Architectural Review Board Regular Meeting Agenda: February 18, 2021

2. Study Session for Architectural Review Board Review of Draft Objective Standards That Would Modify Title 18 (Zoning Ordinance) of the Palo Alto Municipal Code

3. PUBLIC HEARING / QUASI-JUDICIAL. 650 Clark Way [20PLN-00134]: Recommendation on Applicant's Request for Approval of a Major Architectural Review to allow in-channel creek bank stabilization of the Children's Health Council property. The proposed project will install a live log crib wall with a rock toe within San Francisquito Creek to prevent future erosion impacts. Environmental Assessment: A Mitigated Negative Declaration (MND) was circulated from February 5, 2021 to March 7, 2021 in accordance with CEQA. Zoning District: PF (Public Facilities). For more information contact the Project Planner at Claire.raybould@Cityofpaloalto.org.

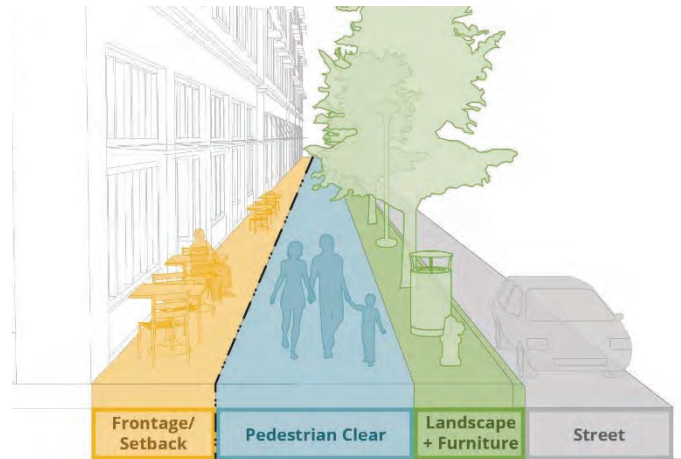
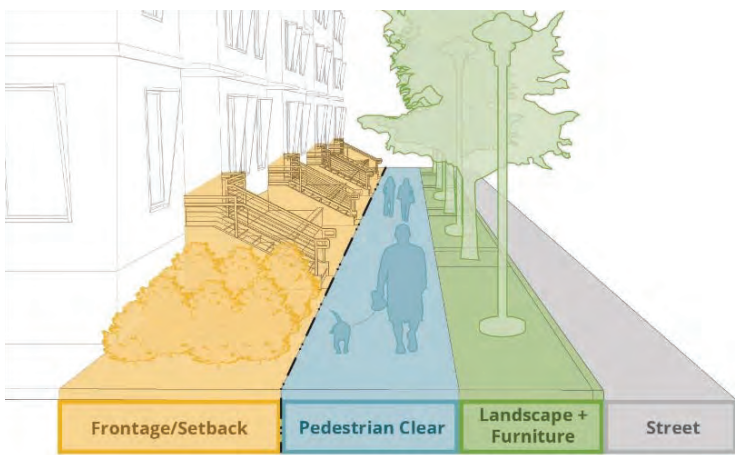
COVID ERA SUGGESTION, WITH 6' SIDEWALKS, CONSIDER WAITING/PASSING ZONES IN LANDSCAPE AREA, TO ALLOW FOR PHYSICALLY DISTANCED PASSING

(i) Treatment of Corner Buildings

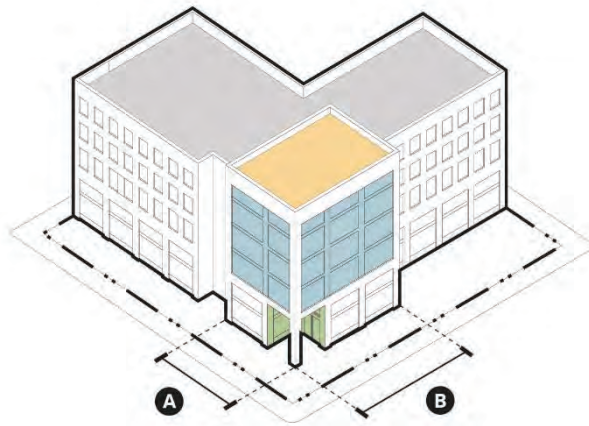
IS THERE A SECTION FOR MID-BLOCK BUILDINGS, WITH NEIGHBORS ON ON 2 SIDES? 1

-
- ☰ Number: 1 Author: elaine Subject: Text Box Date: 12/5/2020 2:11:08 PM
IS THERE A SECTION FOR MID-BLOCK BUILDINGS, WITH NEIGHBORS ON ON 2 SIDES?
-
- 📄 Number: 2 Author: elaine Subject: Highlight Date: 12/5/2020 1:52:08 PM
60 feet
-
- ☰ Number: 3 Author: elaine Subject: Text Box Date: 1/18/2021 8:53:29 AM
WHY 60'? THE HISTORIC BUILDING AT RAMONA AND UNIVERSITY AVE - ONE OF PALO ALTO'S MOST ICONIC BUILDINGS - PROBABLY WOULD NOT MEET THIS STANDARD
-
- ☰ Number: 4 Author: elaine Subject: Text Box Date: 12/5/2020 2:23:55 PM
CORNER TREATMENTS MAY HAVE DIFFERENT CONSIDERATIONS ALONG ECR OR SAN ANTONIO VS UNIVERSITY AVE. EVEN A CORNER BLDG ON A SMALLER STREET LIKE LYTTON AVE OR COLLEGE AVE MAY NEED DIFFERENT STANDARDS

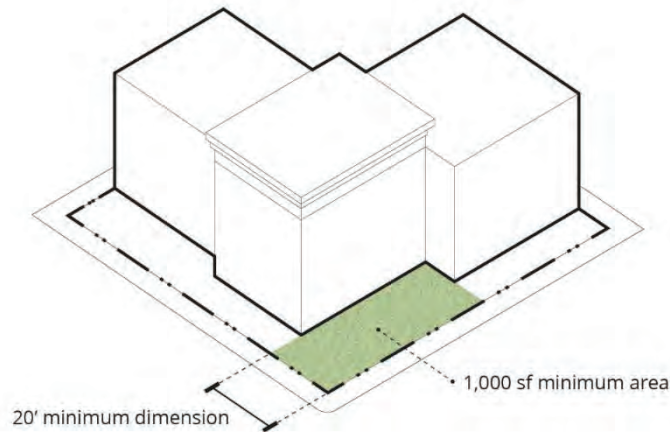
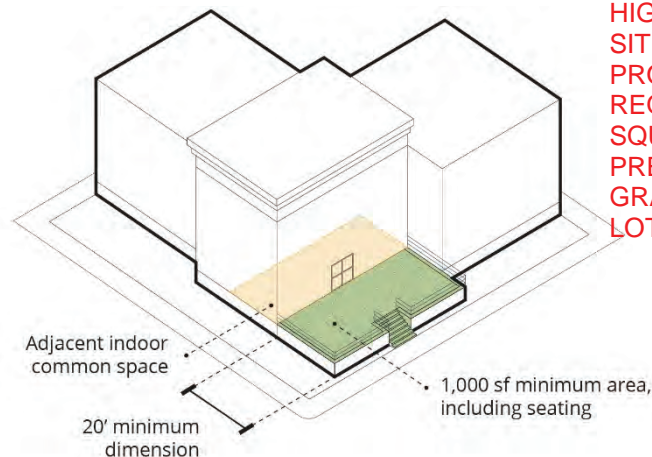
² NARROW DEPTH SITES MAY NEED AN EXEMPTION. A LOT OF GOOD PUBLIC ACTIVITY CAN HAPPEN IN A 12-15' DEPTH. 1000SF OVERALL SEEMS HIGH (20'X50'!), ESPECIALLY ON SMALLER SITES. RECOMMEND 500 SF MIN OR A GRADUATED MINIMUM BASED ON MINIMUM LOT SIZE (IE 500 SF FOR SITES < 1/4 ACRE, 750 FOR SITES < 1/2 ACRE AND 1000 SF FOR SITES OVER 1/2 ACRE.

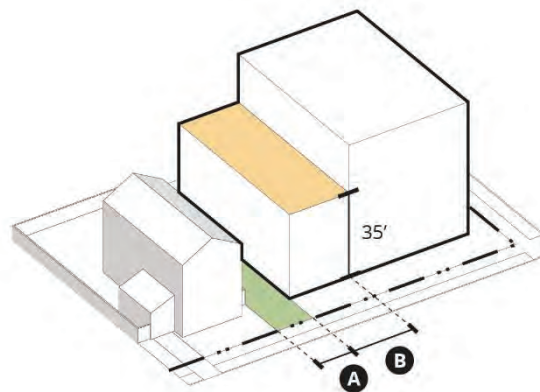
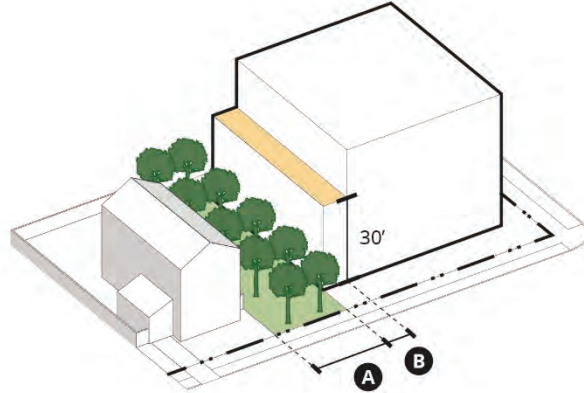
RIGHT SIDE DIAGRAM OF THIS BLDG IS THE TALLEST ALLOWABLE IN PALO ALTO RIGHT NOW! YOU MAY WANT TO EDIT TO SHOW RELATIONSHIP BETWEEN 2 STORY AND 4 STORY STRUCTURE

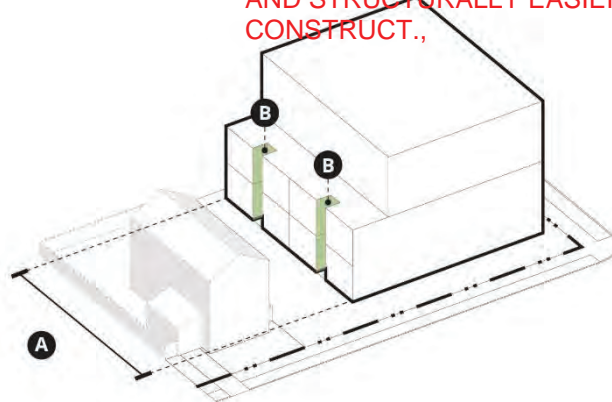
6' DEPTH IS A LOT ESPECIALLY ON SMALLER SITES, <100' IN ONE DIRECTION. 2-3' IS BETTER AND STRUCTURALLY EASIER/CHEAPER TO CONSTRUCT.,

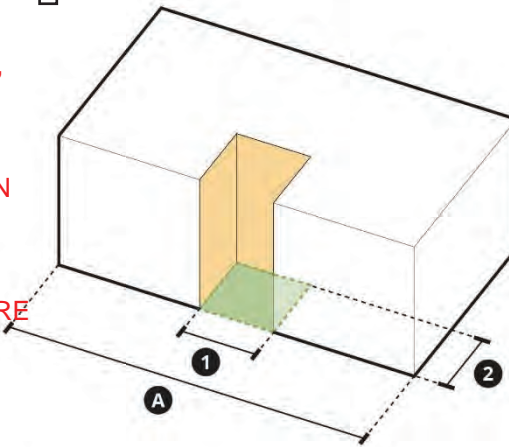
100' LONG SITES ARE NOT THAT LONG/WIDE, INSTEAD OF MANDATING THIS HUGE BREAK, USE MASSING TO CONTROL VARIATION ALONG A FACADE, ALTERNATIVE: CHANGE 100' TO BLDGS OVER 200' IN LENGTH

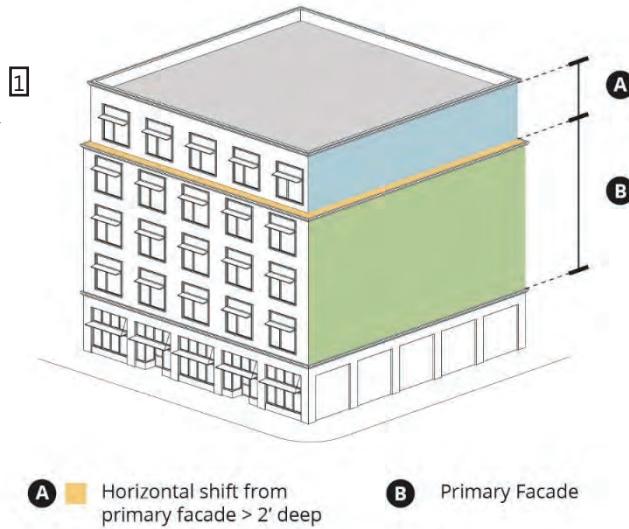
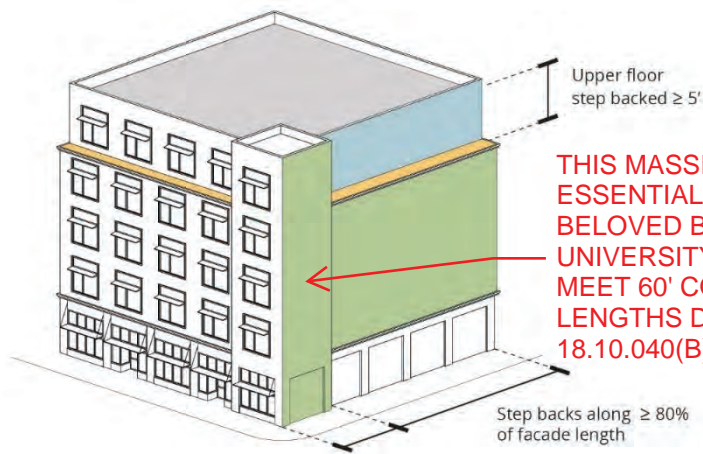
LOVE THESE DIAGRAMS, BUT THEY ILLUSTRATE BUILDINGS TALLER THAN PALO ALTO'S CURRENT 50' HEIGHT LIMIT (WE SHOULD ALLOW STRUCTURES THIS TALL THOUGH!)

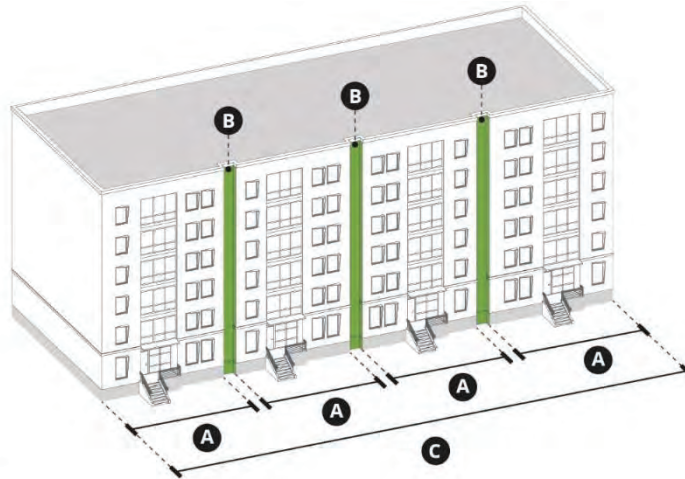
THIS MASSING IS GOOD, ESSENTIALLY A DIAGRAM OF THE BELOVED BUILDING AT RAMONA & UNIVERSITY, BUT IT MIGHT NOT MEET 60' COMBINED CORNER LENGTHS DESCRIBED IN 18.10.040(B)i(a)1

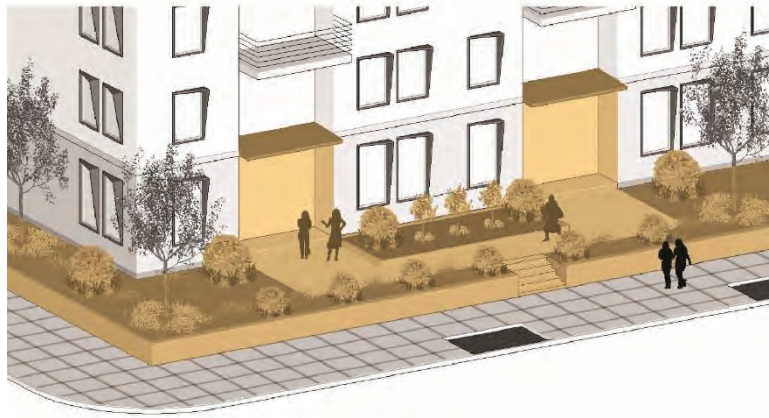
BE CONSISTENT WITH 18.10.024.(C)ii WHICH SAYS 36 SF AND MIN 5' DIMENSION
